Amendments to the Drawings:

Annotated Sheet Showing Changes to Fig. 8 on Sheet 4/5

FIG.8

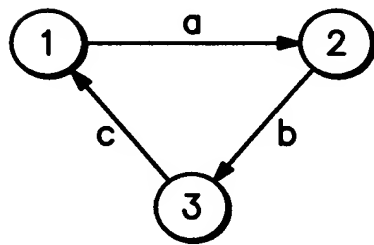
The attached sheets of drawings are formal replacements for all of the drawings previously submitted. The attached sheet of drawings include a change to Fig. 8 on sheet 4/5. In Figure 8, the direction of arrow b has been reversed to be consistent with Fig. 7 and basic understanding of a state diagram. Without this change path a and path b would be redundant, which would not be correct for a state diagram.
